1997 - 1999 Corvette: Service Bulletin: Loose or Missing Headlamp Door Bezel Plug

Subject: Loose or Missing Headlamp Door Bezel Plug (Install New Bezels and Plugs)

Number: 99-08-42-005

Models: 1997-99 Chevrolet Corvette

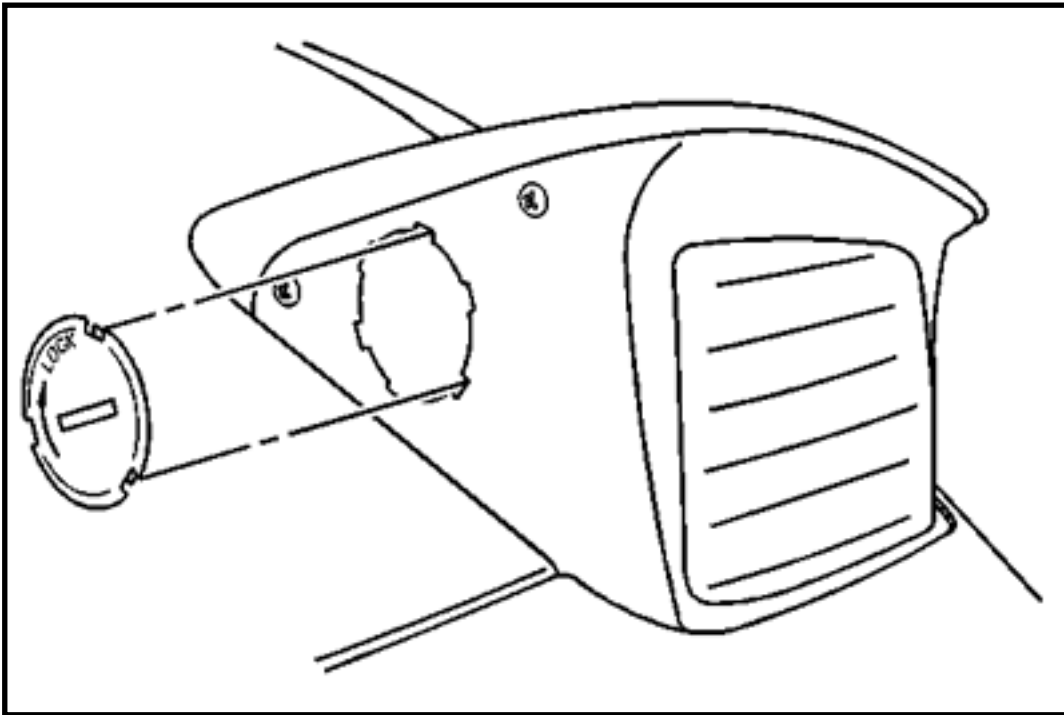
Some customers may comment that the plastic plug that covers the headlamp aiming adjustment screw on the inboard side of the headlamp door bezel is loose or missing.

Two different size plugs have been used in production. Early production 1997 vehicles used a plug with a diameter of 24 mm (15/16 in), while later 1997 vehicles and all 1998 and 1999 vehicles use a larger 54 mm (2 1/8 in) diameter plug. Both size plugs have been replaced by a new design plug and, therefore, will no longer be available.

Using the following service procedure, replace both the left and right headlamp bezels with the new design bezels that have a large NOTCHED hole. The notched hole is required for installing a new design NOTCHED plug.

1. Open the engine compartment hood.
2. Turn the headlamp switch to the ON position (the headlamp doors will open and the lamps will illuminate).
3. Turn the headlamp switch back to the PARK lamp setting (headlamp doors will remain open).
4. Remove and discard both the left and the right headlamp bezels and plugs, following the information in the Body & Accessories section of the appropriate Service Manual.
5. Install the new left and right headlamp bezels.
6. Align the notches on the new plug with the notches in the opening in the new headlamp bezel.
7. Using a quarter or a flat-bladed screwdriver, slowly rotate the plug in

the direction shown by the arrow on the outside of the plug until a click can be heard or felt.
